MEMORANDUM

DESCRIPTION: Outline planning application for the erection of up to 120 dwellings with public open space, landscaping and sustainable drainage system (SuDS) and vehicular access point from the A44. All matters reserved except for means of access.

APPLICATION NO: 190111

Consultation response from: Nigel Koch, Senior Landscape Officer

Figure 2: Historic map, circa 1843-1893

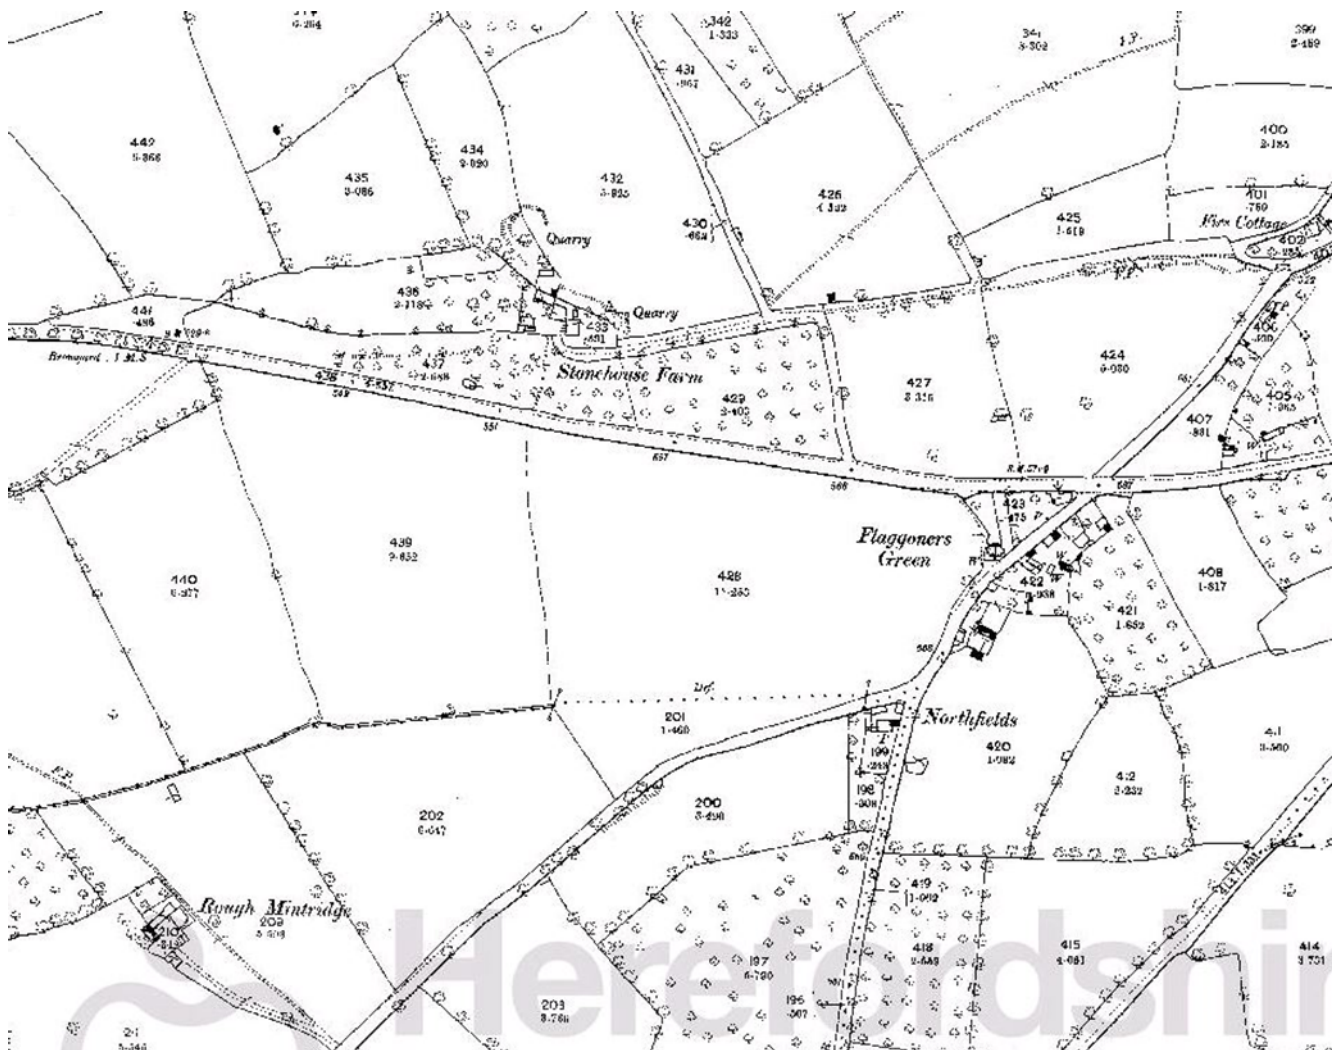
- Observing historic map data, circa 1843-1893 (Figure 2), with an aerial photograph (Figure 1), shows:
 - Urban development has significantly altered the landscape character.
 - Field structure is relatively intact.
 - Extent of orchards reduced overtime, however a remnant traditional orchards remains in close proximity to the proposed access location.
